Access Compliance Report Public Rights-of-Way (Curb Ramps)

Main Street: KENSINGTON_RD Cross Street: GERTRUDE_DR Location: SW

ADA ID: RPRK211220142316 Ramp Type: Type 1 - Perpendicular Diagonal Initial Pass/Fail: Fail Overall Compliance: No Severity Score: 15

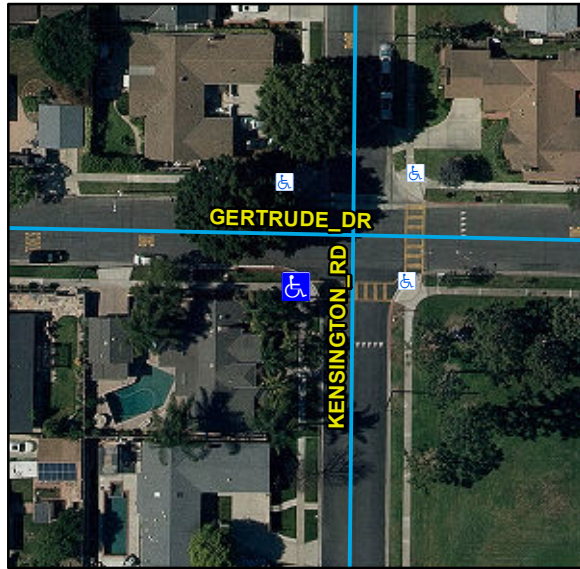
R304.2.2, R204.3, STD 1115

Remove & Replace Curb Ramp With Two New Directional Ramps or Equivalent.
